SUBJECT: THREE MILE ISLAND UNIT-2 INDEPENDENT SPENT FUEL STORAGE  
INSTALLATION INSPECTION REPORT 07200020/2018-001

Report Number: 07200020/2018-001

Facility: Three Mile Island Unit 2 Independent Spent Fuel Storage Installation

Figure 1 TMI-2 ISFSI

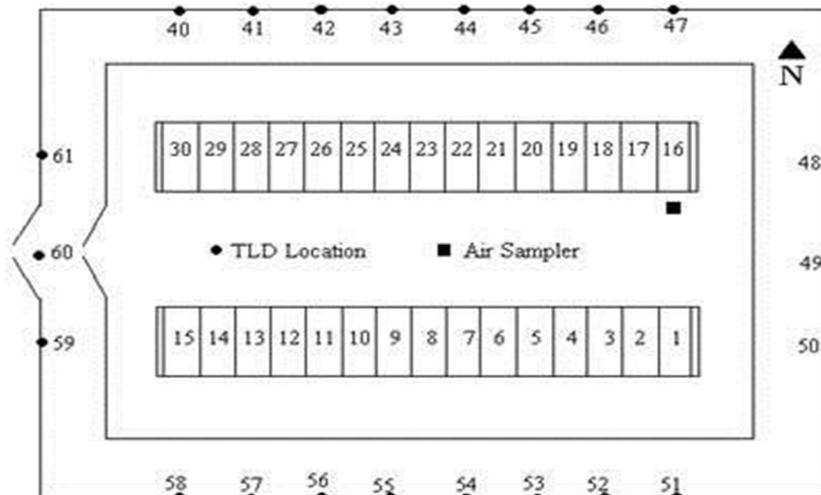
Thirty HSMs were situated on the TMI-2 ISFSI pad. Twenty-nine were loaded with spent fuel debris from the TMI-2 reactor. One additional HSM was placed on the pad with an oversized overpack installed to serve as a backup in case one of the DSCs developed a leak and needed confinement. The 30 HSMs were arranged in two rows of 15 with door openings facing inward, numbering 1–15 on the south row and 16–30 on the north row, going east to west (see Figure 1, above).

The walk-down of the ISFSI pad found the concrete to be in good condition. There was no overt vegetative growth in or around the pad. No flammable or combustible materials were observed on the ISFSI pad. There was a low volume air sampler situated on the ISFSI pad in close proximity to HSM #16 that was used as part of the periodic airborne radioactivity sampling process to assess airborne radiological environmental impacts due to TMI-2 ISFSI operations. The material condition of the 30 HSMs was observed to be acceptable. Signs of repairs made to the concrete were evident on many of the storage modules. The repairs were intact and appeared to be free from further degradation. All of the inspected hardware, doors, latches, and ports installed in the TMI-2 HSMs were in good condition.
